# *City of Brisbane*

## *Planning Commission Agenda Report*

**SUBJECT:** **90 Kings Road;** R-1 Residential District; Grading Review for construction of new single-family dwelling on an approximately 6,728 square foot property, requiring 1,159 cubic yards of soil cut and 38.75 cubic yards of soil fill on the property. Site grading and construction would require removal of one protected street tree, qualifying as a protected tree under BMC Chapter 12.12; Kevin Wong, applicant; Yaoxiang Lu and Guimin Ren, owners.

**G-3**

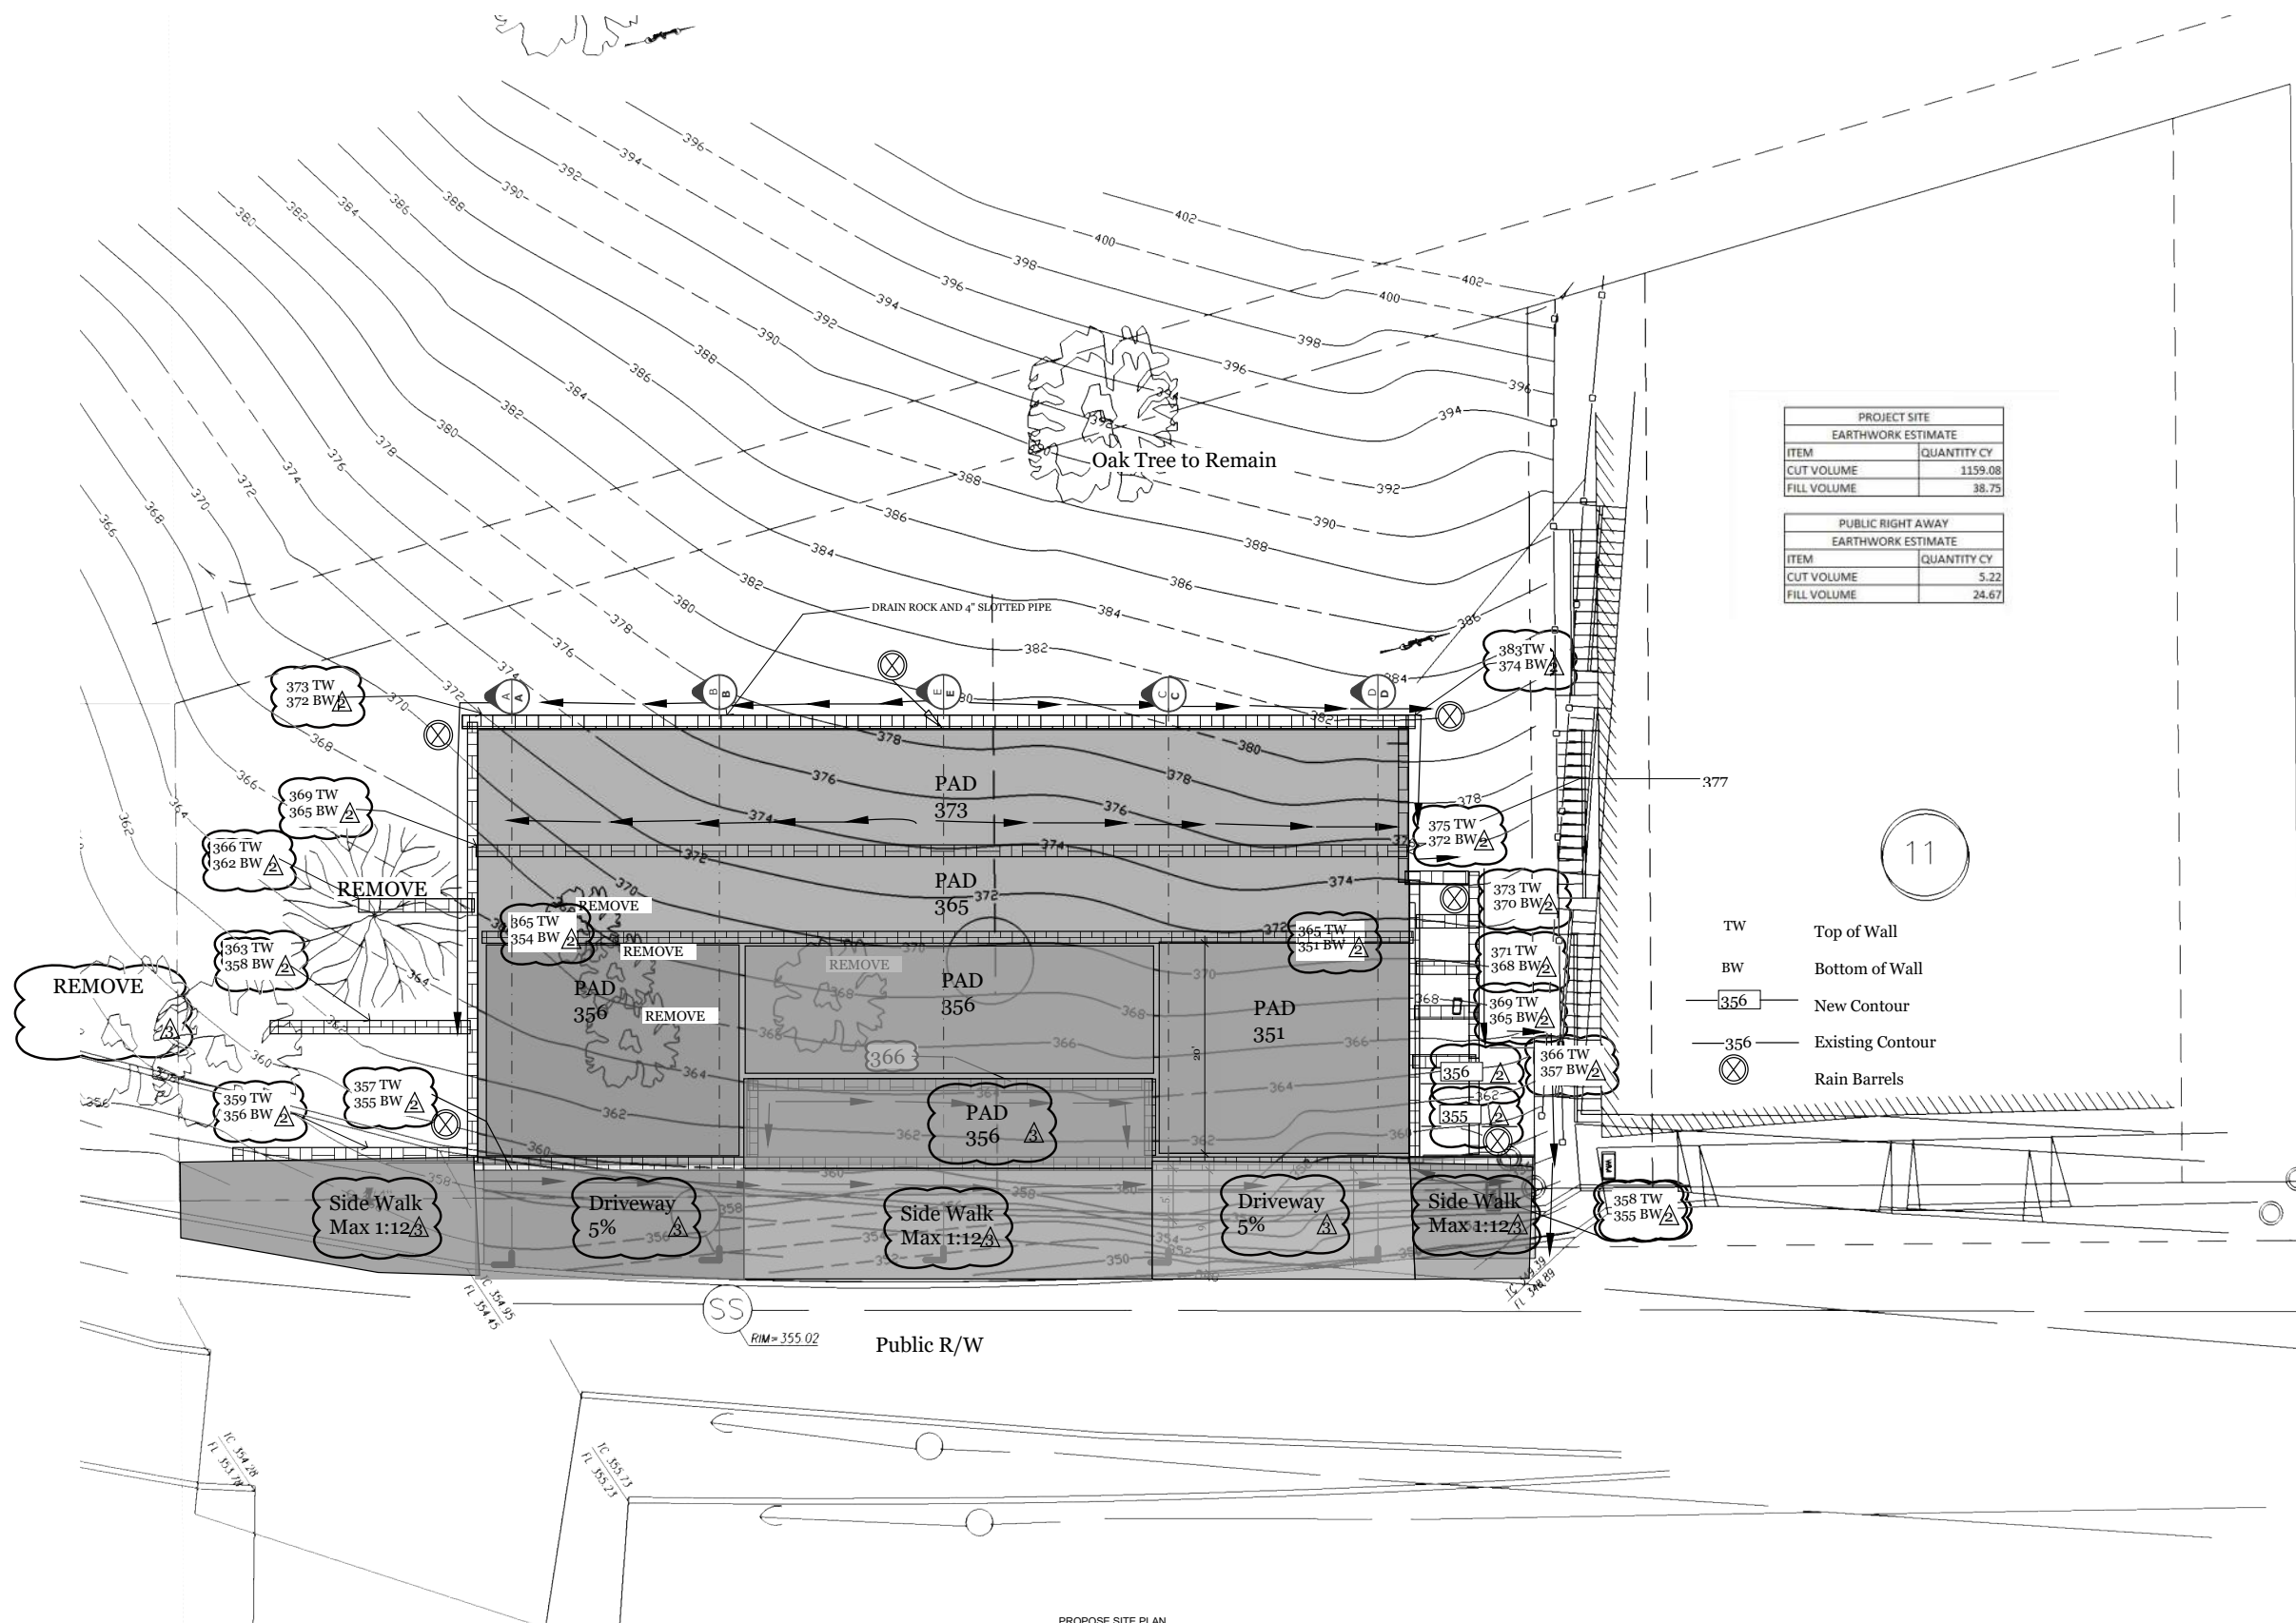
As noted above, the proposed grading would result in several exposed retaining walls within the north and south side yards of the property (refer to sheet G-3 of the applicant's plans, attached). Walls would range in height from 3 to 5 feet in the south side yard. In the north side yard, a 9 foot wall would be located adjacent to the garage, with three lower walls ranging in height from 4 to 3 feet above. The 9 foot wall in the north side yard would be visible from the sidewalk.

BMC §17.32.050 requires vegetative screening or wall treatments for retaining walls over six feet in height if they are located within a setback area. For this project, that requirement applies to the 9 foot wall in the north side yard. Conditions of approval A.1 and A.2 in the attached resolution requires that the landscaping plan submitted with the building permit include vegetative screening for these walls such that no more than six feet of the wall (horizontally) is visible, or that the wall is treated with different materials to break up the wall massing in six foot segments. These conditions would apply to any additional walls identified after the project undergoes grading permit review by the City Engineer.

2. All exposed retaining walls exceeding six feet in exposed height from grade in the shall be either planted with screening plantings such that no more than six (6) feet of the height of the retaining wall will remain visible, or varying treatment and materials at six foot horizontal intervals may be incorporated into the wall design. The chosen screening method shall be subject to review and approval by the Community Development Director.
